Project **IEEE 802.16 Broadband Wireless Access Working Group** <<http://ieee802.org/16>>

Title **Clarifications for Comment # 84 and # 85**

Re: IEEE P802.16e/D10

Figure 132-TEK state machine flow diagram

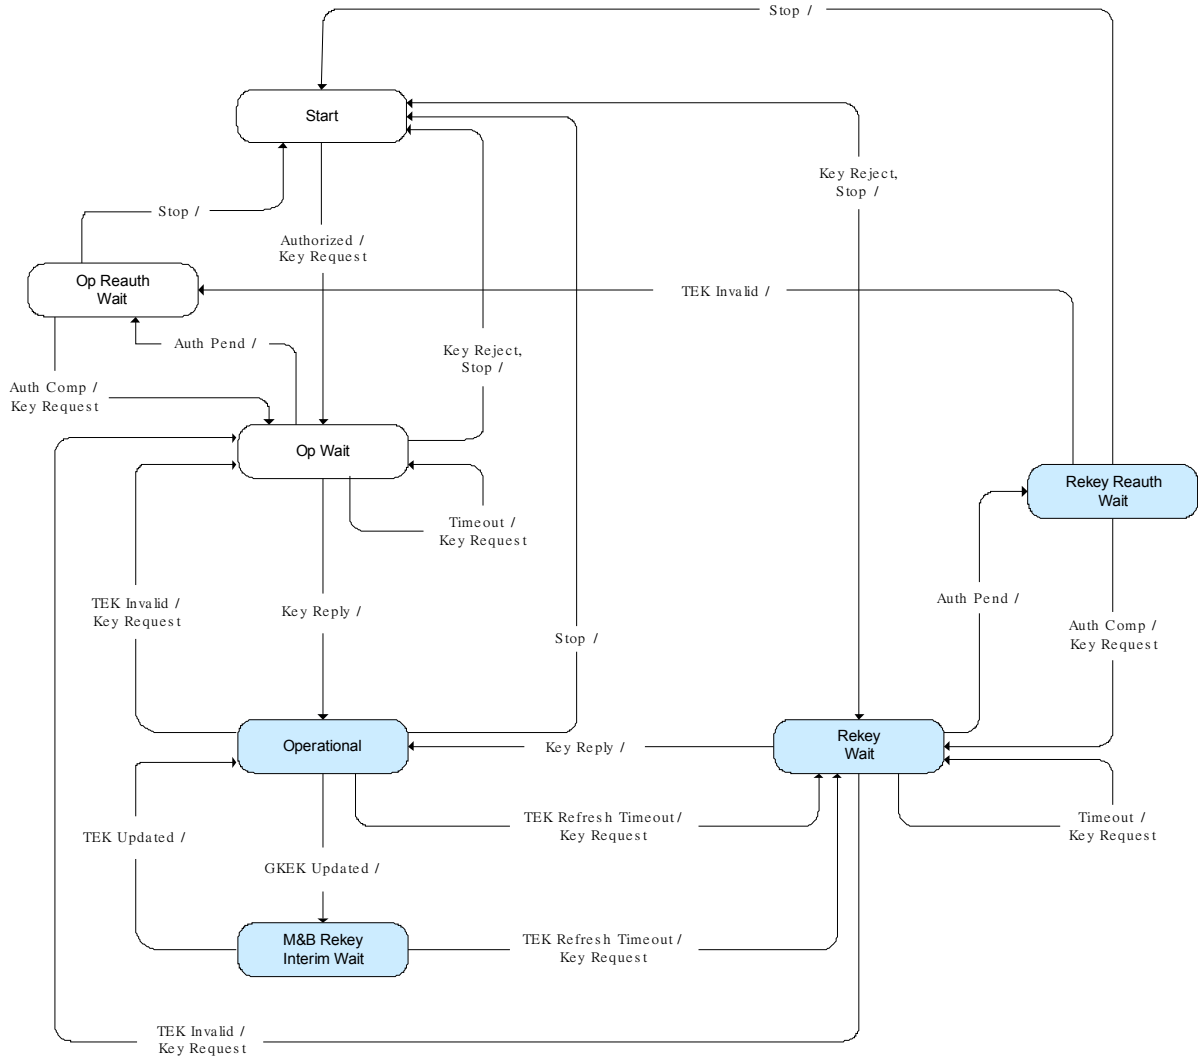
This documentation is to clarify the figure mentioned in Comment # 84 and # 85.

[Proposed figure]
